# Access Compliance Report

## Public Rights-of-Way

### (Curb Ramps)

Intersection ID: N/A	Main Street: PAISLEY_ABBEY_LN	Cross Street: KELBURN_LN	Location: NE
ADA ID: E7FFC4639E28	Ramp Type: Perp	Initial Pass/Fail: Fail	Overall Compliance: No
		Severity Score: 8.75

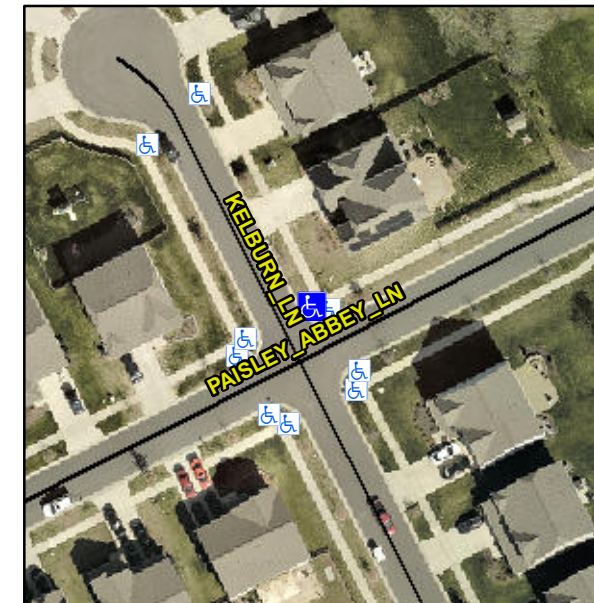
**Not Found, R304.5.1**

Compliance	Description	Data	Compliance	Description	Data
N/A	Ramp Length (in)	98.0	Yes	Ramp Slope (%)	5.4
No	Ramp Width (in)	38.0	Yes	Ramp XSlope (%)	1.4
N/A	Flare Type LT	N/A	N/A	Flare Type RT	N/A
N/A	Flare Slope LT (%)	N/A	N/A	Flare Slope RT (%)	N/A
N/A	Flare Traversable LT?	N/A	N/A	Flare Traversable RT?	N/A
N/A	Landing Length (in)	N/A	N/A	DWS Provided?	N/A
N/A	Landing Width (in)	N/A	N/A	DWS Contrast?	N/A
N/A	Landing Slope (%)	N/A	N/A	DWS Length (in)	N/A
N/A	Landing X Slope (%)	N/A	N/A	DWS Full Width?	N/A
N/A	Landing Curb? (Y/N)	N/A	N/A	DWS Offset (in)	N/A
N/A	Shared Landing?	N/A			
N/A	Gutter Ponding?	N/A	N/A	Gutter Slope (%)	N/A
N/A	Gutter Lip Ht (in)	N/A	N/A	Gutter X Slope (%)	N/A
N/A	Painted X Walk1?	No	N/A	Painted X Walk2?	N/A
	X Walk 1 Direction	To SW		X Walk 2 Direction	N/A
N/A	X Walk 1 Width (in)	N/A	N/A	X Walk 2 Width (in)	N/A
	X Walk 1 Slope (%)	0.8		X Walk 2 Slope (%)	N/A
	X Walk 1 X Slope (%)	1.9		X Walk 2 X Slope (%)	N/A

**Remove & Replace Entire Ramp.**
